**SUBJECT: CONDITIONAL USE/CLASS 3 SITE PLAN REVIEW/CLASS 2
ADJUSTMENT CASE NO. CU-SPR-ADJ18-08
3700 PORTLAND ROAD NE
AMANDA NOS. 18-112263-ZO, 18-112264-ZO & 18-112265-RP**

Summary: An application to convert part of an existing building to a motor vehicle sales use and reconfigure part of an existing vehicle use area for parking and vehicle display.

1 / PROPOSED SITE PLAN

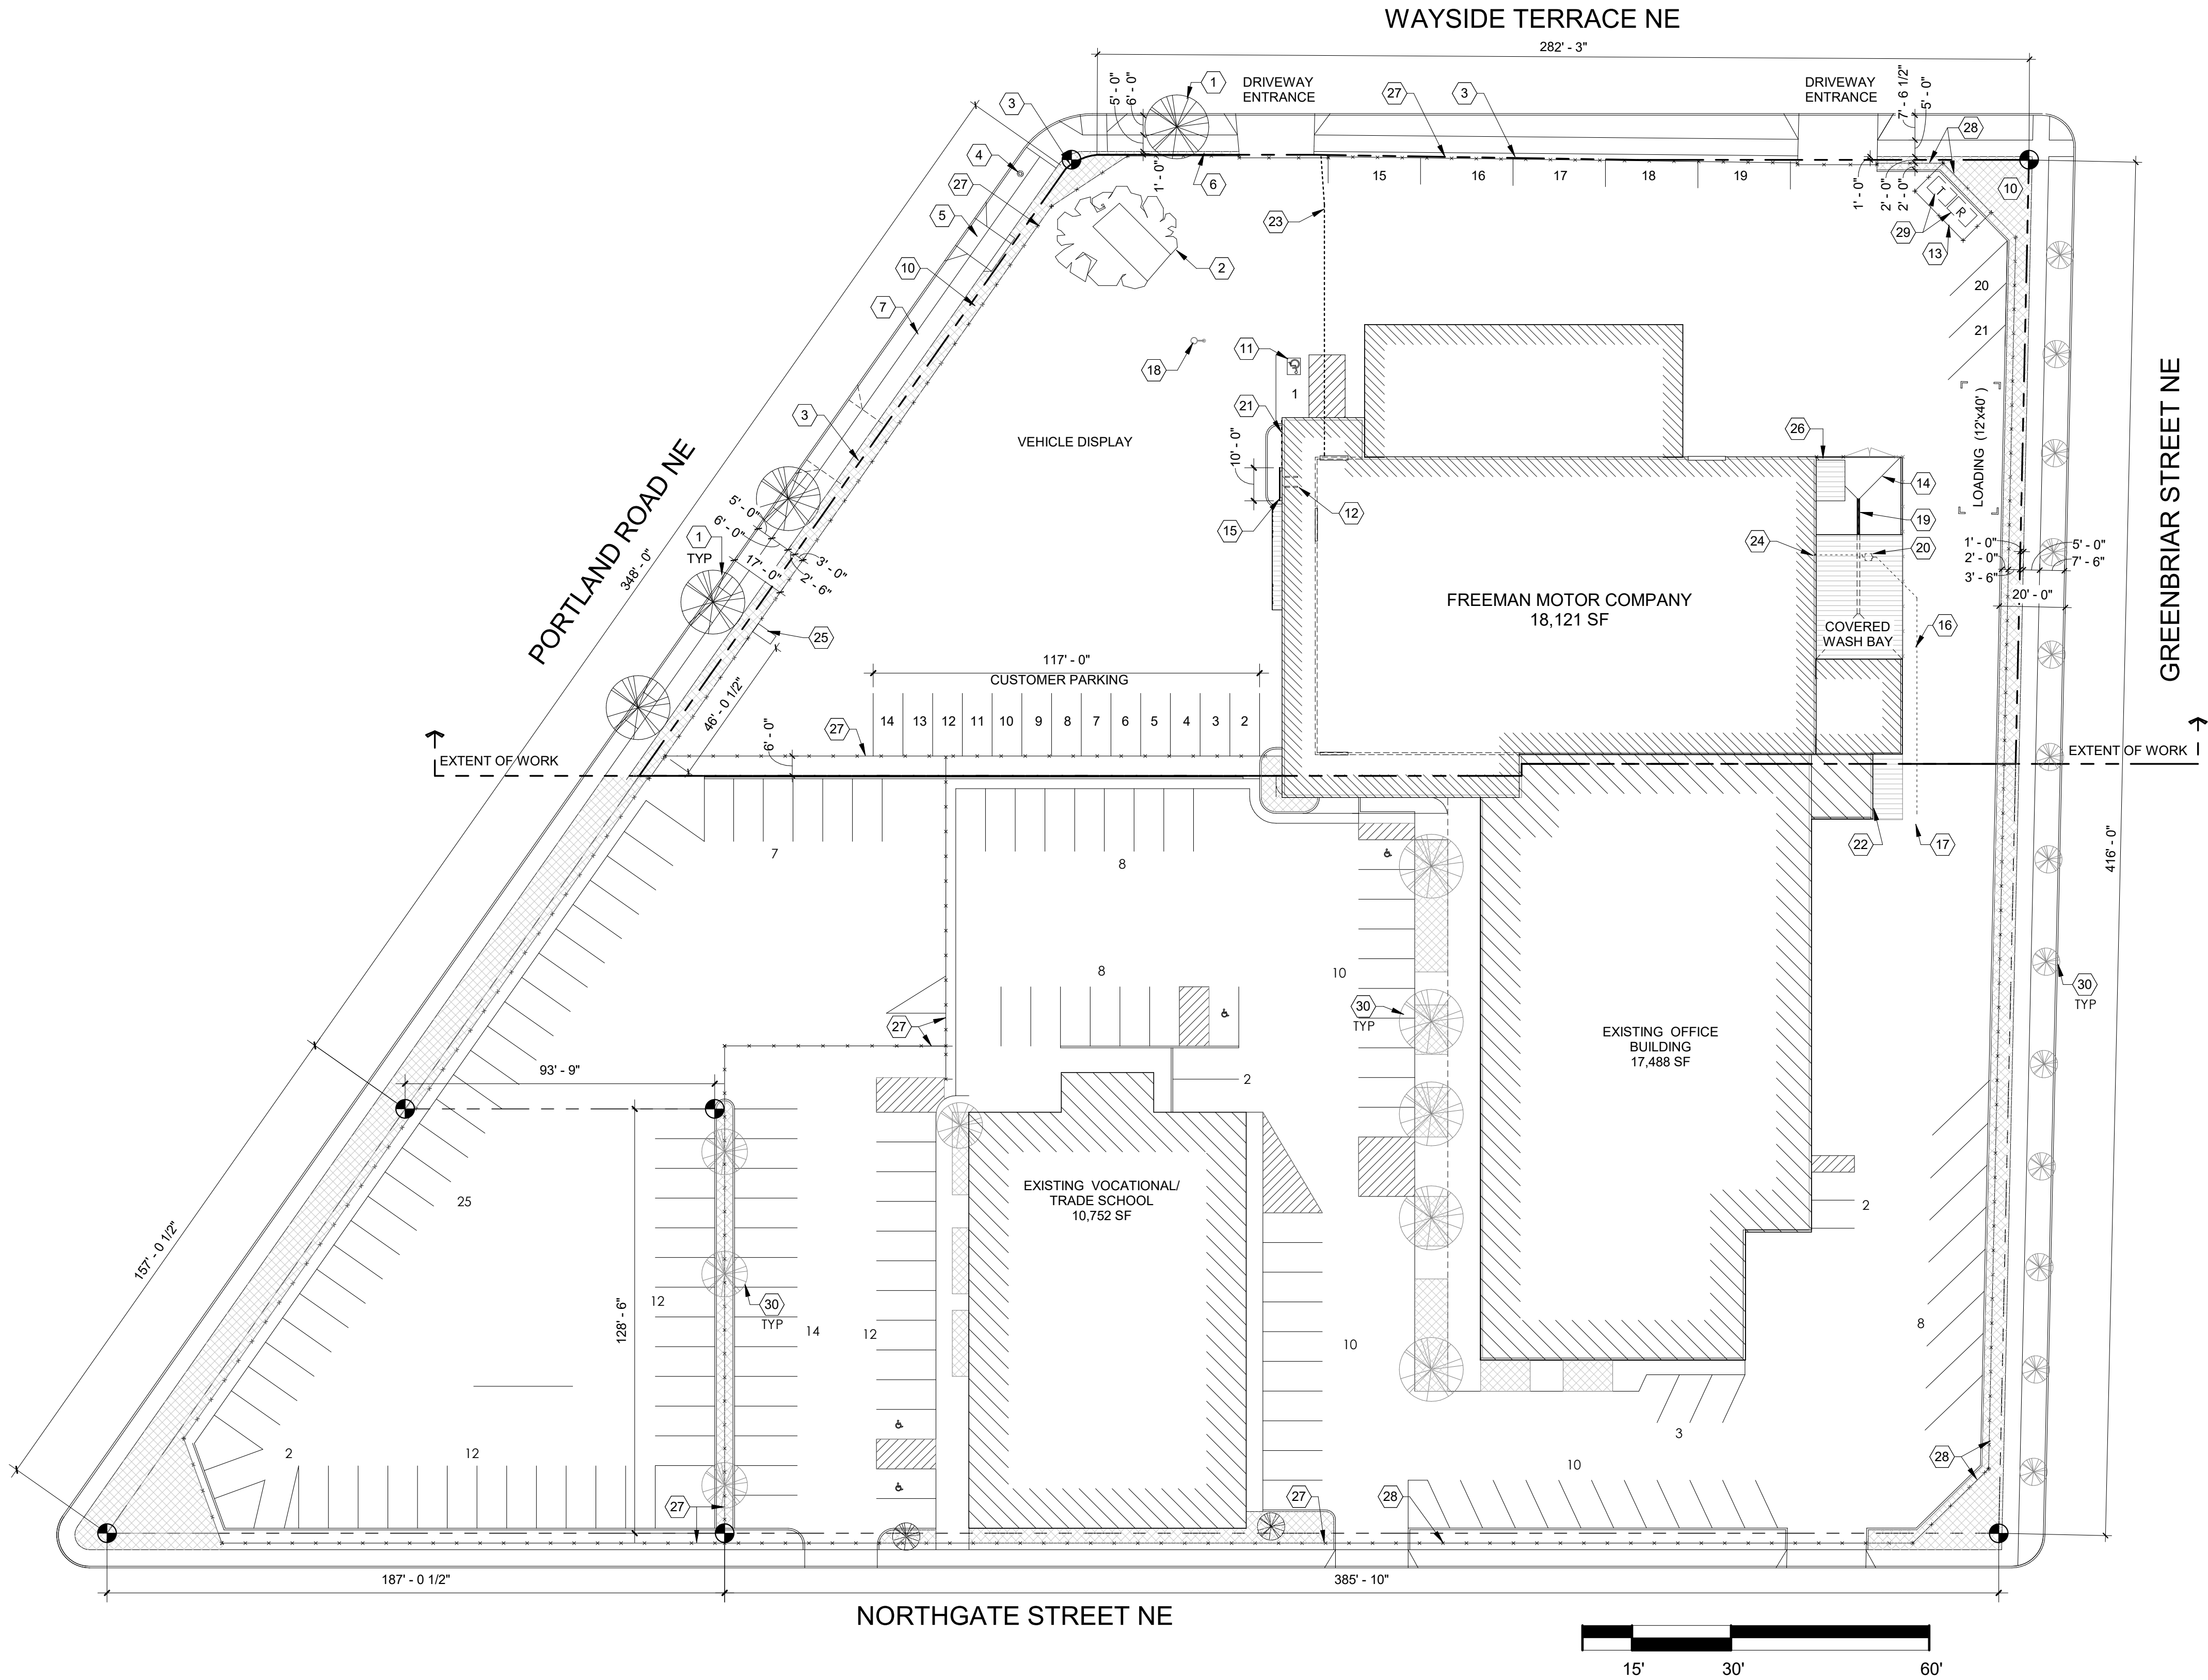
Finding: The proposed site plan does not indicate details of the solid waste receptacle area. Therefore, the following condition is necessary:

Condition 1: The proposed development shall be in substantial conformance with the approved site plan included as Attachment C, as modified by the conditions of approval.

Condition 5: Prior to building permit issuance, the applicant shall provide evidence that the proposed solid waste service area will comply with the standards of SRC 800.055.

PLANTING PLAN

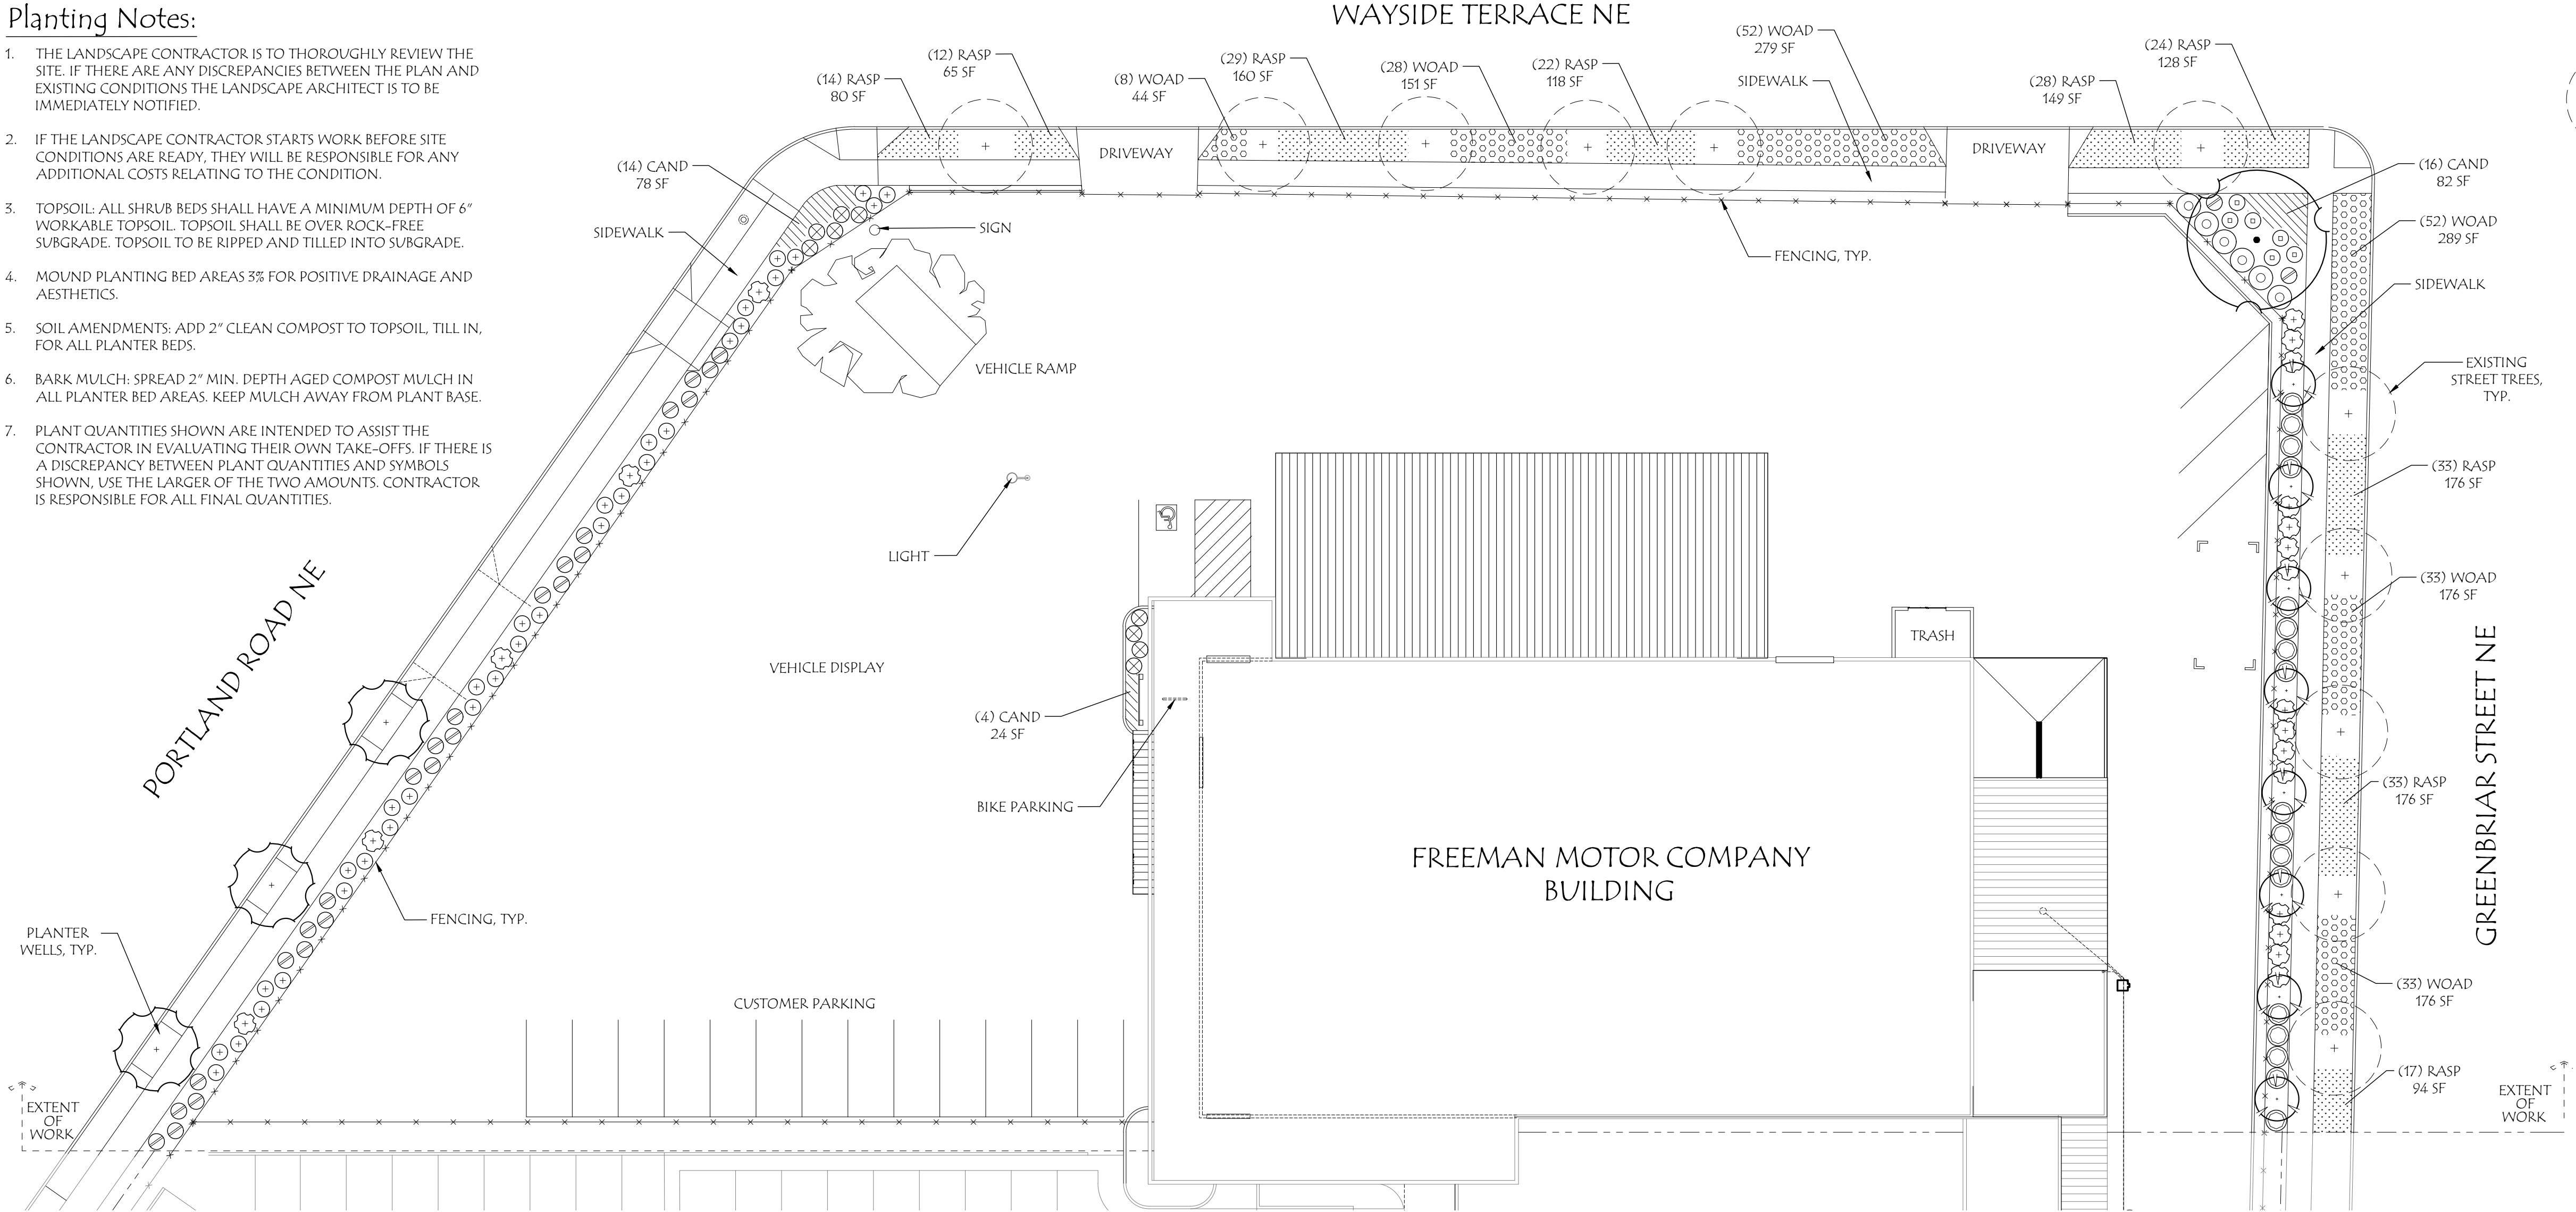
As proposed, the landscaping area for the development site would increase by 2.3 percent to 8,057 square feet inside the property lines, requiring a minimum of 403 plant units; the landscaped area would increase by 9.3 percent to 2,135 square feet within the project area, and 5,922 square feet of existing landscaped areas would remain within the remainder of the development site. Of the 403 minimum plant units required, at least 40 percent, or 161 of the required plant units, shall be a combination of mature trees, shade trees, evergreen/conifer trees, or ornamental trees. The proposed landscape area within the right-of-way would provide an additional 2,791 square feet, and the conditions of approval would require planting those areas with at least 140 plant units, including 56 tree plant units.

While the proposed landscape plan does not comply with the minimum standard, the development, as proposed, will bring the nonconforming site into greater conformance with the landscaping requirements by providing new landscape area where no landscaping currently exists.

The applicant is advised to consult with the Public Works Urban Forester regarding allowable street trees in the public right-of-way. Additional trees may be required on the landscape plan to meet the landscaping requirements of Condition 3.

Condition 2: The location and width of the proposed landscaping areas shall be in

Condition 3: All proposed landscape areas, including those in the public right-of-way, shall be planted with a minimum of 1 plant unit per 20 square feet of landscape area and shall be irrigated. A minimum of 40 percent of the required number of plant units shall be a combination of shade trees, evergreen/conifer trees, or ornamental trees.
